# UNITED STATES PATENT AND TRADEMARK OFFICE

10/785,348

<b>Office Action Summary</b>	<b>Application No.</b> 10/785,348	<b>Applicant(s)</b> SHELSON ET AL.	
	<b>Examiner</b> LAURA C. SCHELL	<b>Art Unit</b> 3767

## DETAILED ACTION

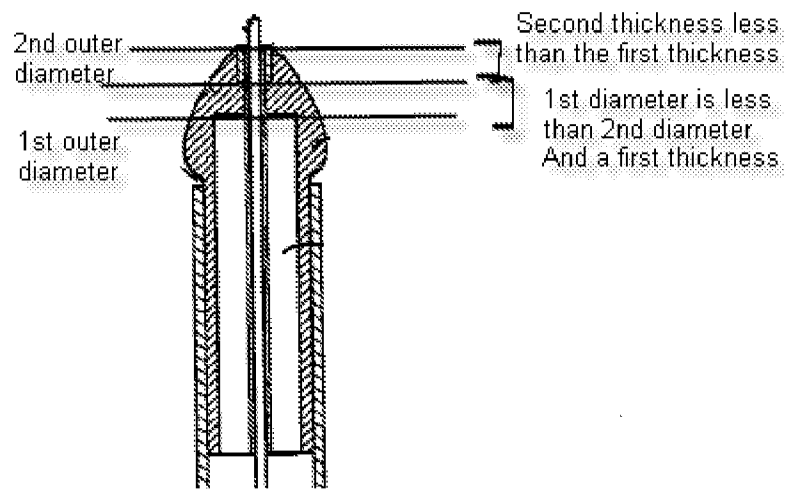
In reference to claim 21, Griffin discloses that the flexible portion is proximal of the radially inextensible distal portion (portion 31 is proximal to 202), wherein the flexible portion tapers from a first outer diameter at a first location along the tip to a second outer diameter less than the first outer diameter at a second location along the tip distal of the first location (see Figs. 49 and 50 and the marked-up version of Fig. 49 at the end of the office action).

In reference to claim 22, Griffin discloses that at the first location along the tip, the tip has a first thickness and a first inner diameter, and wherein at the second location along the tip distal of the first location, the tip has a second thickness less than the first thickness and a second inner diameter greater than the first inner diameter (see Fig. 49 and the marked up version of Fig. 49 at the end of the office action).

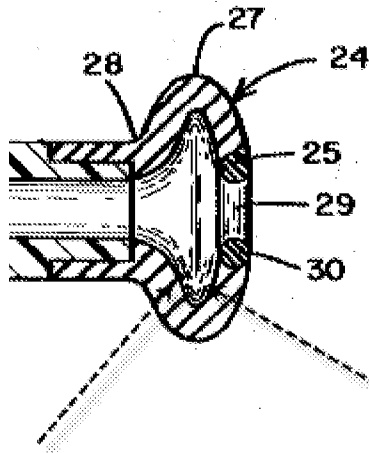
a tip with a hardened crystalline portion. However, as referenced in the rejection above, Muni discloses that the pattern of soft amorphous portions and hardened crystalline portions can be varied, thus indicating that it is possible to have a tip with a hardened crystalline portion. Applicant also argues that the Van Tassel reference does not show the tip inverting into the proximal portion of the tip lumen. It is the examiner's position, however, that the inner wall portions bordering the hinge line in the tip portion, are not contacting each other, thus there is space between the inner wall portions on either side of the hinge line for the wall portions to come closer together and contact each other, which would result in the tip inverting into the proximal portion of the lumen if a force is applied that results in pushing the inner wall portions together. Therefore it is the examiner's position that Van Tassel discloses a device which is perfectly capable, if not configured to provide a tip that can invert into the proximal portion of the lumen. The examiner thinks it would greatly help advance prosecution if the independent claim language were amended to recite the structural differences (varying diameter of the tip lumen along the length of the tip, thickness of the wall at points along the length of the tip lumen, etc.) found in Applicant's Figs. 3-5 as compared to the cited references.

The arrows point to portions of the inner wall on either side of the hinge line. Since the inner wall on either side of the hinge line is not in contact with itself, space exists for the distal tip to move further and have the inner wall on either side of the hinge line come into contact with itself, which would result in the tip inverting into the tip lumen.
